Ref.: AN 7/64.1.3- 25/51

Subject: Proposals for the amendment of Annex 10, Volume III relating to satellite communication systems in support of ASBU Blocks 1 and 2, arising from the seventh meeting of the Data Communication Infrastructure Specific Working Group of the Communications Panel (CP-DCIWG/7)

PROPOSED AMENDMENT TO
INTERNATIONAL STANDARDS AND RECOMMENDED PRACTICES
ANNEX 10
TO THE CONVENTION ON INTERNATIONAL CIVIL AVIATION
AERONAUTICAL TELECOMMUNICATIONS
VOLUME III
COMMUNICATION SYSTEMS

Figure 4-1. CPDLC and ADS-C measurement points

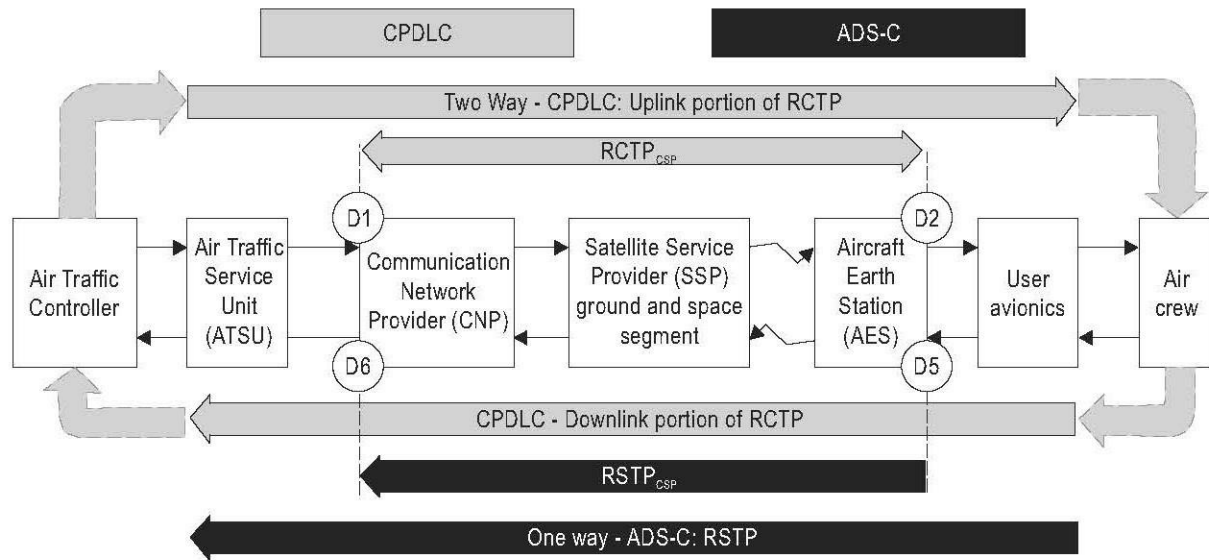
4.6.4.1.2 The AMS(R)S system shall ensure that at least 95 per cent of all CPDLC messages transmitted by the ATSP or aircraft and routed through the SATCOM link are delivered without corruption or misrouting with a two-way transit delay of no more than 100 seconds (see *Note 1* following Figure 4-1).

4.6.4.1.4 The AMS(R)S system shall ensure that at least 95 per cent of all ADS-C messages transmitted by the aircraft and routed through the SATCOM link are delivered without corruption or misrouting with a one-way transit delay of no more than 84 seconds (see *Note 2* following Figure 4-1).

4.6.4.1.6 The AMS(R)S system shall ensure that at least 99.9 per cent of all CPDLC messages transmitted by the ATSP or aircraft and routed through the SATCOM link are delivered without corruption or misrouting with a two-way transit delay of no more than 120 seconds (see *Notes 1 and 3* following Figure 4-1).

4.6.4.1.8 The AMS(R)S system shall ensure that at least 99.9 per cent of all ADS-C messages transmitted by the aircraft and routed through the SATCOM link are delivered without corruption or misrouting with a one-way transit delay of no more than 170 seconds (see *Notes 2 and 3* following Figure 4-1).

Note 1.— *The “two-way data transit delay” is measured between D1 and D2 for uplink and between D5 and D6 in downlink in Figure 4-1. This includes the transit delay for the following components:*

Note 2.— The “one-way data transit delay” is measured between D5 and D6 in Figure 4-1. This includes the transit delay for the following components:

Note 3 — For the message latency allocations, the CSP consists of the CNP and SSP. Additional information is available in the Manual on the Aeronautical Mobile Satellite (Route) Service (Doc 9925).
